Location: 2819 Government Boulevard

Mertz Court Subdivision, Block 1, Resubdivision of Lot 27

• Subdivision approval to create one (1) legal lot of record from one (1) metes-and-bounds parcel.

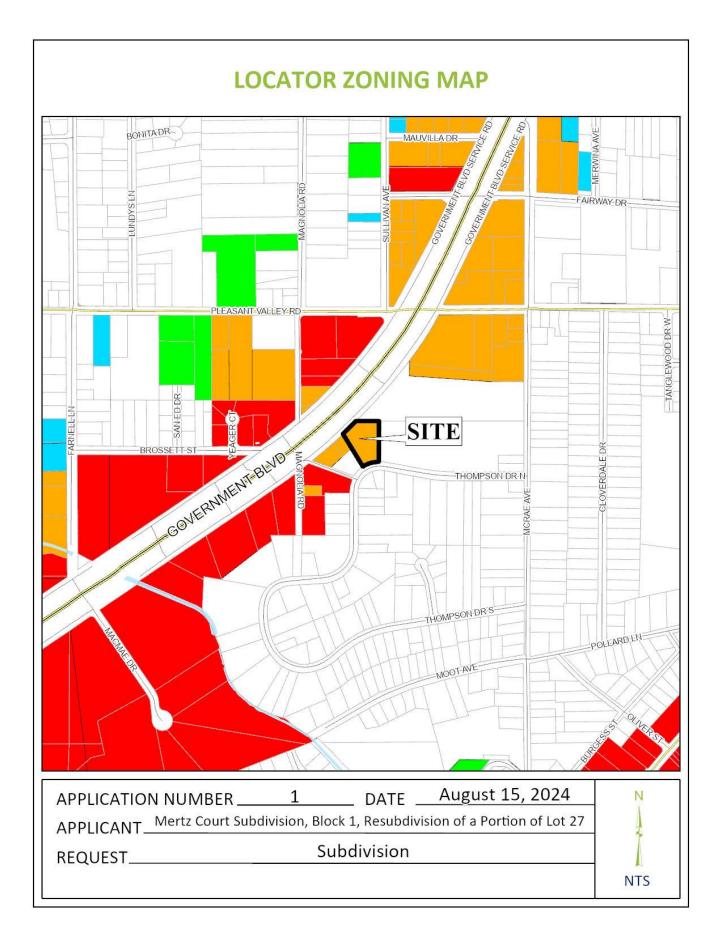
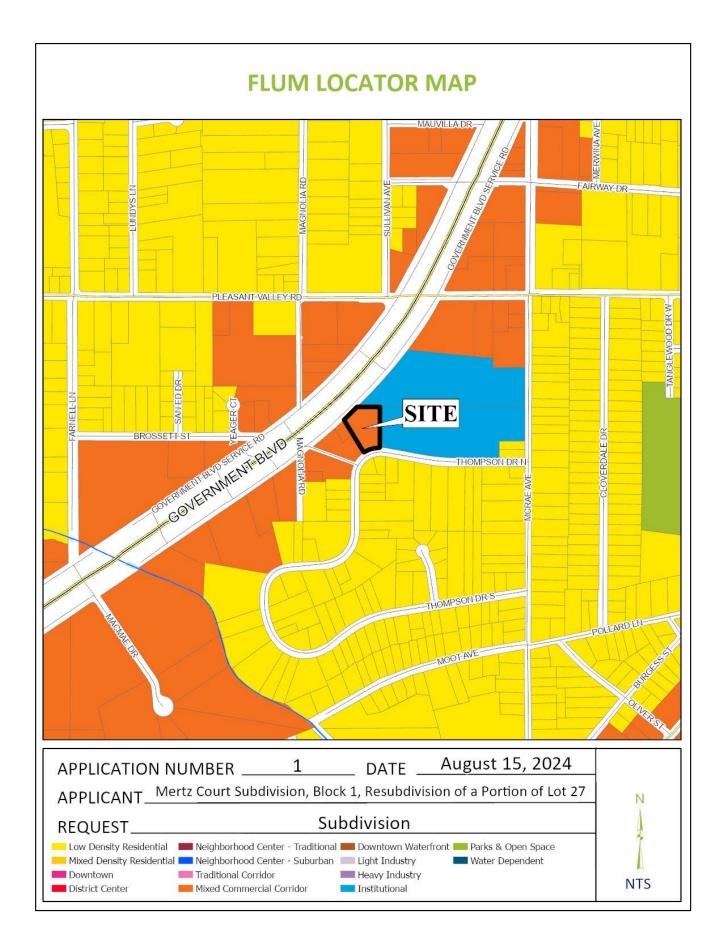
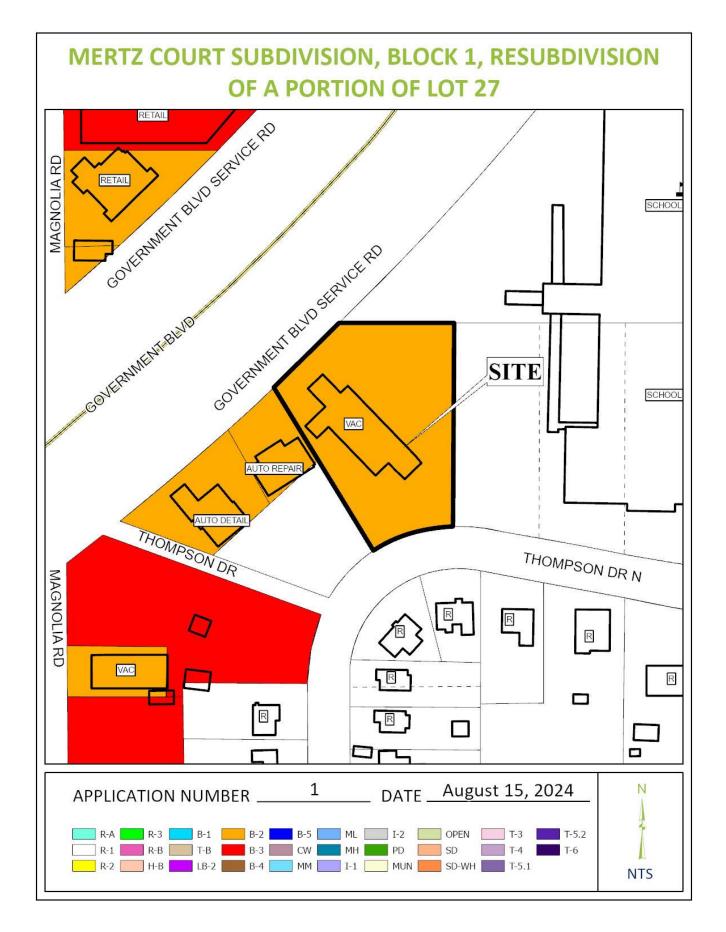
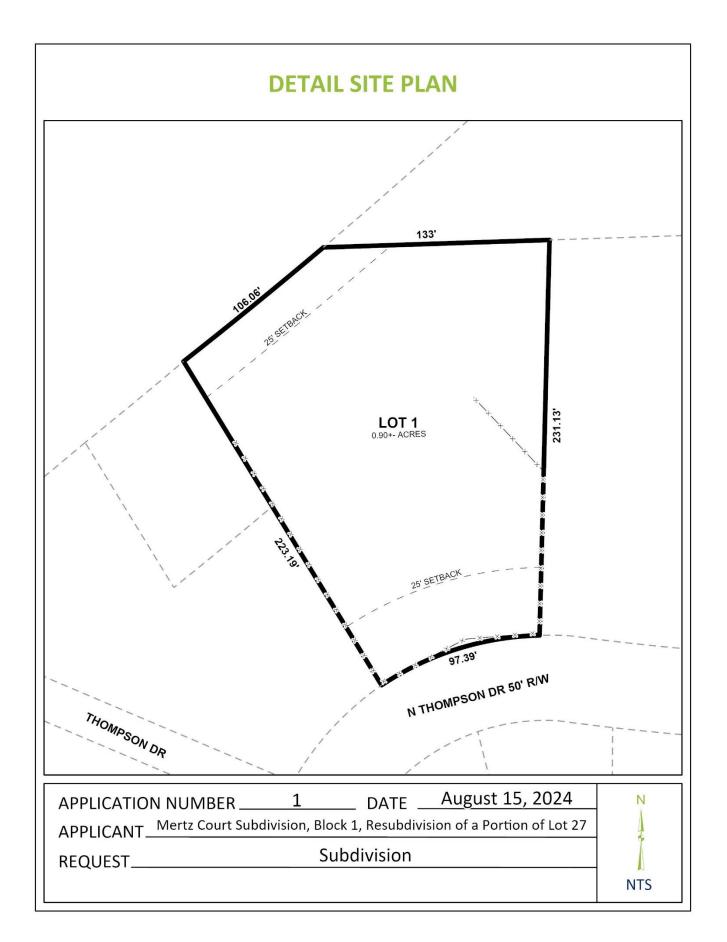
The site has frontage on Government Boulevard, an ALDOT-maintained Principal Arterial roadway requiring a 250foot wide right-of-way; and on Thompson Drive North, a minor street with curb and gutter requiring a 50-foot wide right-of-way. Adequate right-of-way widths are depicted along both streets on the preliminary plat making additional dedication unnecessary.

Double-frontage lots are discouraged by Section 6.C.7. of the Subdivision Regulations. The site has existed in its current configuration since at least 1984, per aerial photographs, thus a waiver of Section 6.C.7. may be appropriate; however, access must be limited to one (1) street. As such, a note should be placed on the Final Plat, if approved, stating access to Thompson Drive North is denied.

The lot, as proposed, exceeds the minimum size requirements for lots served by public water and sanitary sewer in an B-2 Suburban district, and is appropriately labeled in square feet and acres on the preliminary plat. This information should be retained on the Final Plat, if approved, adjusted for any required dedication; or placement of a table on the Final Plat with the same information will suffice.

A 25-foot front yard setback is illustrated along Government Boulevard and Thompson Drive North, in compliance with Section 6.C.8. of the Subdivision Regulations, and with Article 2, Section 64-2-13.E. of the UDC for lots in a B-2 Suburban District. However, while the setback on Thompson Drive North is labeled as 25 feet, it is actually drawn 40 feet from the Thompson Drive North property line. The location of the setback line should be revised to be 25 feet, or the label revised to be 40 feet. The setback information, as revised, should be retained on the Final Plat, if approved.

- 1. Retention of the right-of-way widths for both Government Boulevard and Thompson Drive North, as depicted on the preliminary plat;
- 2. Provision of a note on the Final Plat stating access to Thompson Drive North is denied;

- 3. Retention of the lot's size in both square feet and acres on the Final Plat, or provision of a table on the Final Plat with the same information;
- 4. Retention of the 25-foot minimum front yard setback along Government Boulevard;

- 5. Revision of the Final Plat to illustrate a 25-foot setback line along Thompson Drive North, or revision of the Final Plat to correctly label the 40-foot setback as depicted on the preliminary plat;
